28F016SV

SPECIFICATION UPDATE

Release Date: May 1997

Order Number 297554-011

Queueable Operation Delay after Power-Up and Exit from Sleep, Power-Down, or Reset

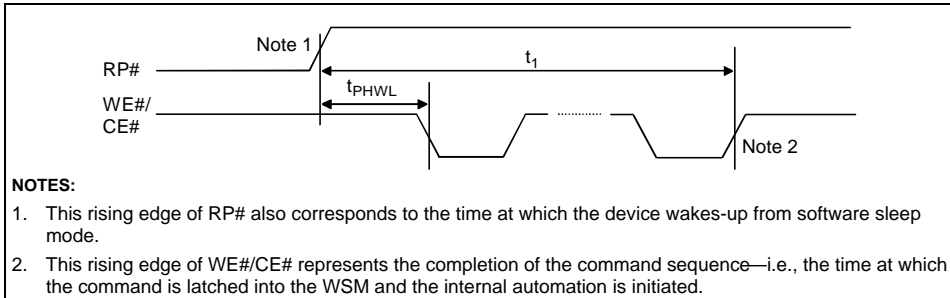
PROBLEM: With the program/erase voltage (V_{PP}) at 5V, the internal V_{PP} detector may not stabilize for up to 5 μ s (illustrated by t_1 in the figure, *Queueable Operation Delay after Power-Up and Exit from Sleep, Power-Down, or Reset*, which follows) after RP# transitions inactive (high). This causes an invalid V_{PP} Level bit indication when reading the Block Status Registers and termination of program, erase or lock block operations due to invalid device V_{PP} error detection. Affected operations include Word/Byte Write (40H/10H), Single Block Erase (20H), Erase All Unlocked Blocks (A7H), Two-Byte Write (FBH), Page Buffer Write to Flash (0CH), and Lock Block (77H).

WORKAROUND: Upon reset, power-up, or wake-up from software sleep or hardware deep power-down, allow 5 μ s (t_1) before initiating a Write/Erase command (as listed earlier) or reading the V_{PP} Level bit of the Block Status Registers (BSR.1). The figure below illustrates this timing requirement (t_1) in more detail.

Example System Software Flowchart That Will Not Encounter “Completion with Command Error or Invalid Device Operation” Condition

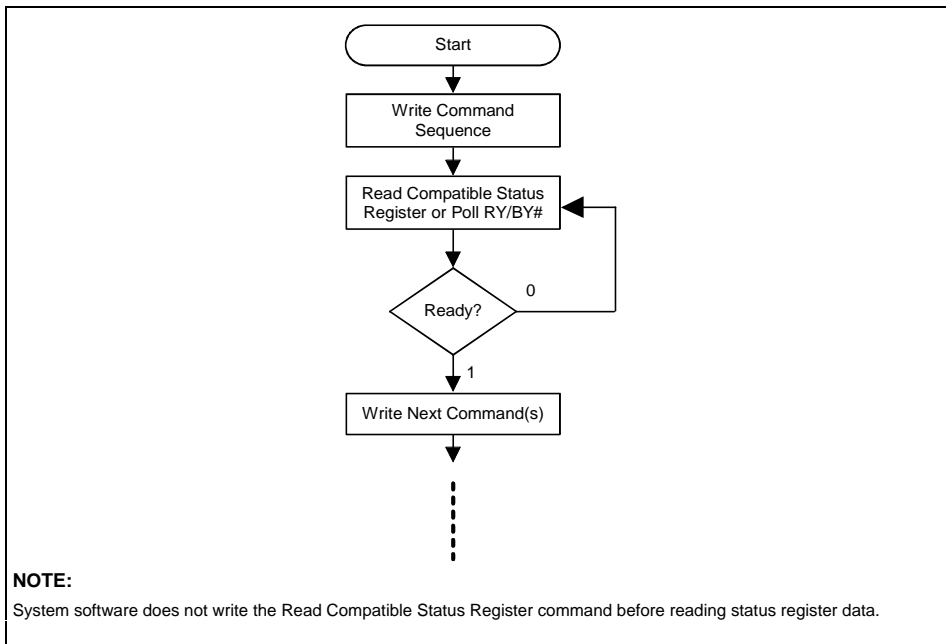
PROBLEM: Systems in which software, after initiating device automation via a queueable command sequence, writes another command(s) to the device before automation completes may initiate unintended device operations.

Systems that poll the RY/BY# pin or WSMS bit (CSR.7) for “Ready” indication before writing another command to the device will not encounter this errata. This is illustrated in the *Example System Software Flowchart, etc.* figure below, and flowcharts 11-1 and 11-2 (without erase suspend) of the *16-Mbit Flash Product Family User’s Manual*.

Timing Waveform Showing Specification Ranges That Will Not Cause the “Completion with Command Error or Invalid Device Operation” Condition

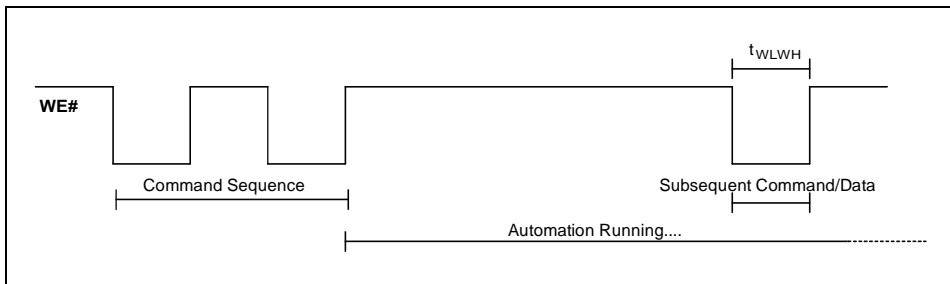
For WE#-Controlled Write Operations, a WE# pulse width defined by the ranges of parameter t_{WLWH} in the table below, will result in a system that does not exhibit this errata (note: timings are also bounded by specifications in the device datasheet). When performing CE#-Controlled Write Operations, this restriction equally applies to the CE# pulse width (t_{ELEH}).

V _{CC} Supply Voltage	t_{WLWH}	t_{ELEH}
5V	<75 ns	<75 ns
3.3V	<100 ns	<100 ns

**Example System Software Flowchart That Will Not Encounter
“Invalid Device Operation” Condition through Checking Queue Status**
(ONLY VALID FOR COMPONENTS WITH DEVICE REVISION CODE 02H, 03H and 04H)

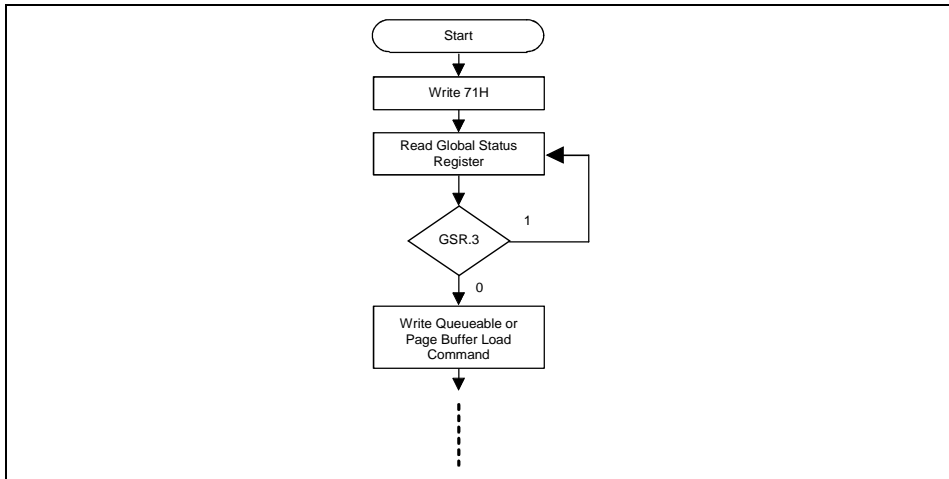
Option 3: Checking Command Queue Availability before Writing to a Page Buffer
(Applicable **only** to components with Device Revision Codes 02H, 03H and 04H)

Before writing Sequential (E0H) or Single (74H) Load to Page Buffer command sequences, poll the QS bit (GSR.3) to determine queue availability. If the queue is available, system software can write a Page Buffer Load command sequence to the device, as shown in the *Example System Software Flowchart, etc.* figure below. This is analogous to the procedure outlined in Chapter 11 of the *16-Mbit Flash Product Family User's Manual* for issuing queueable commands.

Erase Suspend to Read Array with Compatible Status Register

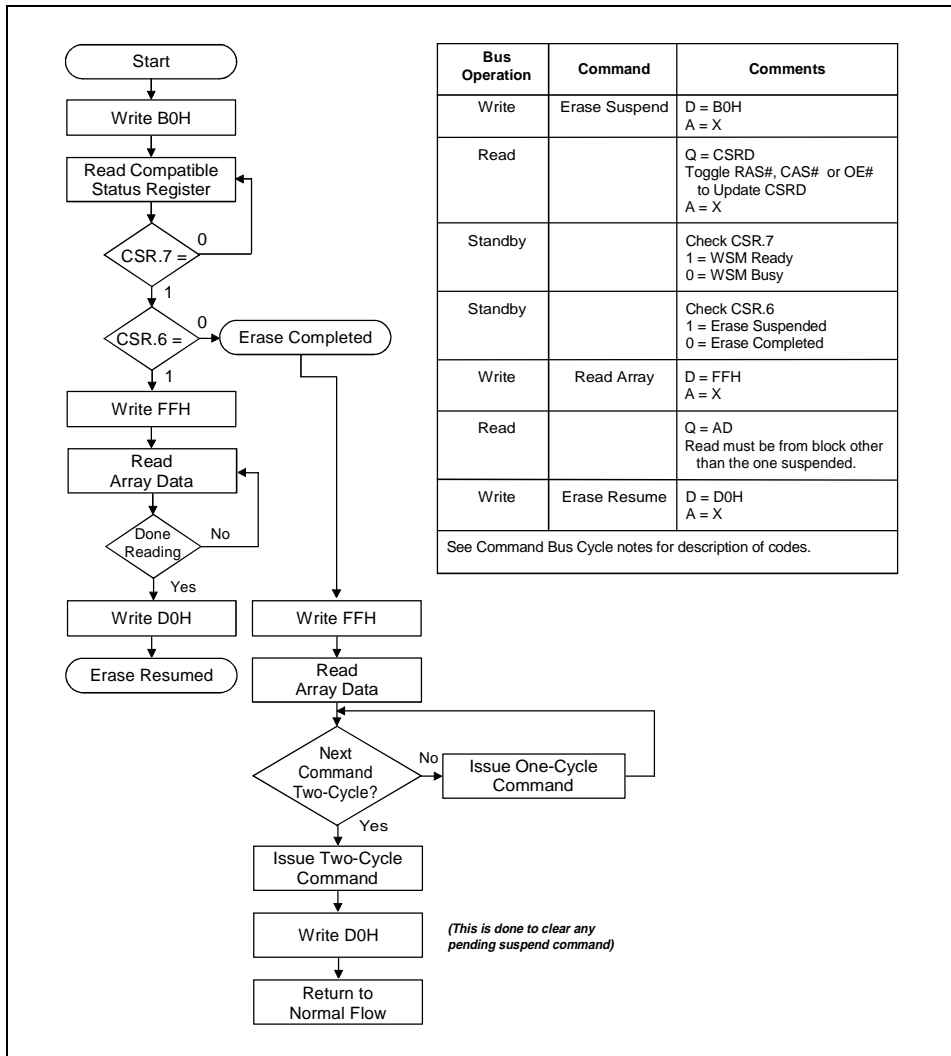
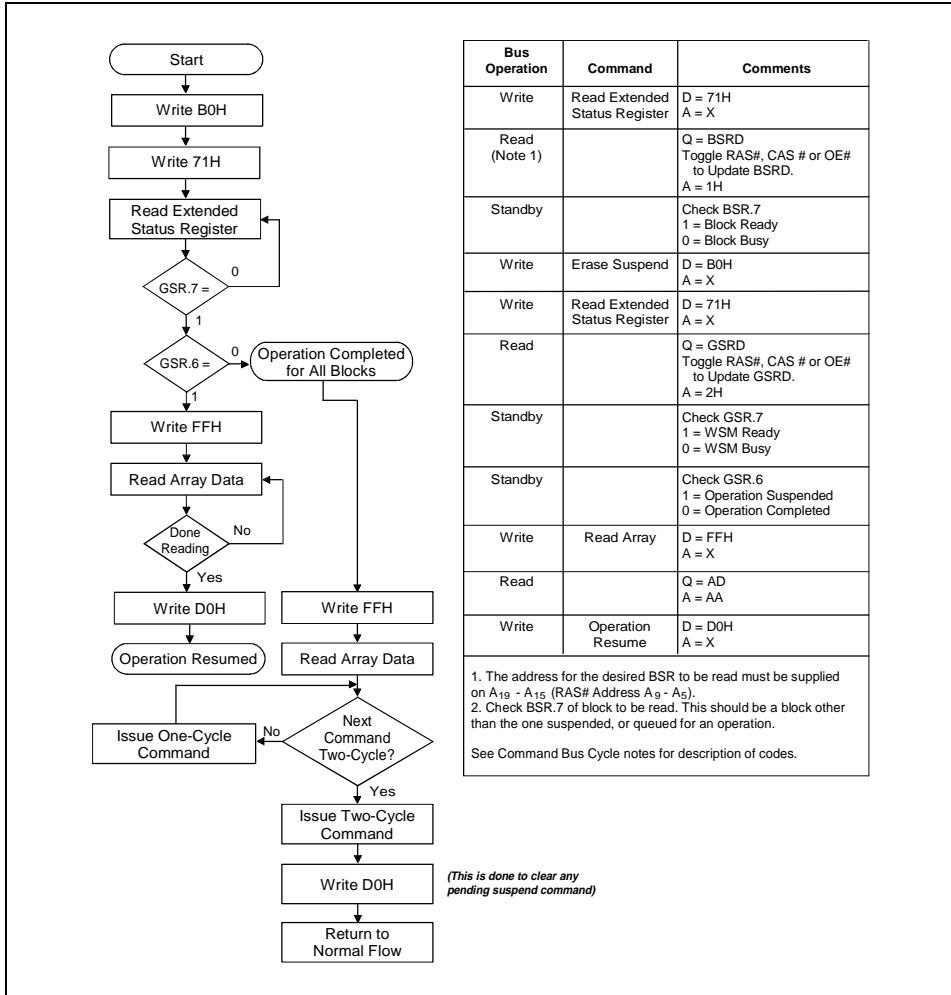
PROBLEM: If an Erase Suspend command is issued late in the Erase algorithm, it will not be recognized by 28F016SV components listed in the Affected Devices section, and erase will complete. This Erase Suspend command will **not** be discarded.

WORKAROUND: A software workaround to this erratum inserts a redundant Resume command (D0H) immediately following any Two-Cycle Command (Word Write, Block Erase, Lock Block, or Upload Status Bits) in the Erase Suspend flowcharts. Modified Erase Suspend to Read Array flowcharts (Figures 11-3 and 11-12 of *the 16-Mbit Flash Memory Product Family User's Manual*) detailing this workaround are shown in the following figures, *Erase Suspend to Read Array with Compatible Status Register* and *Erase Suspend to Read Array with Extended Status Register*. This erratum results in the *Erase Suspend with Compatible Status Register* flowchart being incompatible with the 28F008SA *Erase Suspend* flowchart.
